ADDRESS: 1652 EDISON

APPLICATION NO: #23-8240

HISTORIC DISTRICT: BOSTON EDISON

SCOPE: ALTER FRONT PORCH, REMOVE REAR ENCLOSED PORCH, AND INSTALL REAR DECK

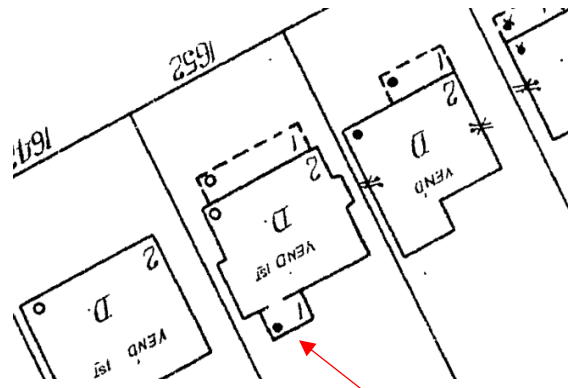
- HDC staff notes that wood paneling/cladding which had been added to the front porch's outermost brick columns without approval has been removed. However, the wood brackets at the porch roof, the slate tile at the porch floor, and the tile and nosing strips at the front porch stairs which were added without COA still remain. The current property owner has therefore submitted the current application to the Commission in an effort to seek this body's approval of the non-compliant work items which remain from the 2017 rehabilitation. See the below photo for the house's current appearance.

- It is staff’s opinion that the front porch brick elements which were replaced in 2017 were highly-visible, distinctive character-defining elements of the property. Therefore, according to the Secretary of the Interior Standards, if these elements were deteriorated they should have been repaired. If the elements were deteriorated beyond repair, they should have been replaced in kind/to replicate the original. It is staff’s opinion that the current wood brackets are not an adequate replication of the original brick elements. Staff therefore recommends that the Commission deny this work item. However, please note that staff does recommend that the wood brackets be painted one uniform color to match the building’s trim if the Commission does decide the approve the current wood brackets.

- Similarly, it is staff’s opinion that the concrete steps and porch floor were highly-visible, distinctive, character-defining elements of the property. The installation of black slate tiles at the porch floor in addition to the ceramic/faux slate tiles and metal nosing at the porch steps do not meet the Standards as the new elements do not replicate the original concrete material. Also, the new porch floor and stair elements are incompatible with the building’s historic appearance as they appear to be more appropriate for an interior application and are not in keeping with the home’s Tudor Revival stylistic detailing.

Staff therefore recommends that the Commission issue a Denial for the wood brackets at the front porch roof, the slate tile at the front porch floor, and the ceramic tile and metal nosing at the front

- The plywood door and window infill at the rear elevation shall be painted a neutral/brown color which is in keeping/compatible with the color of the brick.
- The new wood rear deck shall be painted or stained a color which is keeping/compatible with the home's trim color
